<h1 style="text-align: center;">TSB-Local</h1>	Model	Sorento[XM](all)
	Group	Engine Mechanical System(12)
	TSB No.	KCE11-12-P200- XM;C21VA
Subject Crankshaft damper pulley replacement	Published	9/30/2011
	TSB Type	Service Action
	Area & Distributor	U.K (C21VA)

1. Description

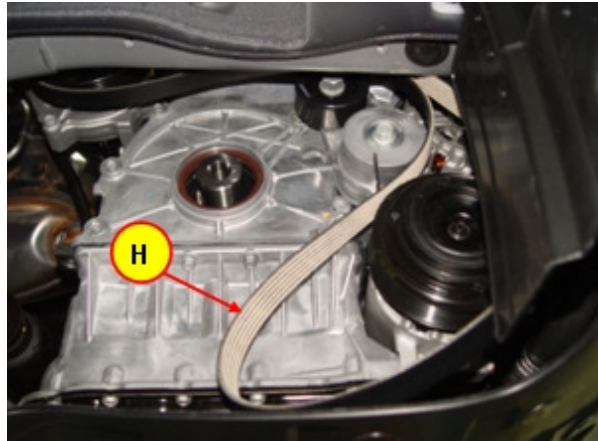
This bulletin has been amended. The following changes are:

- **Tightening process and torque value of the crankshaft bolt.**

7. Install the new damper pulley (I) and new crankshaft bolt (J) to the crankshaft.

Tightening Torque :

196.1 Nm (20.0 kgf.m, 144.7 lb-ft) + 60°
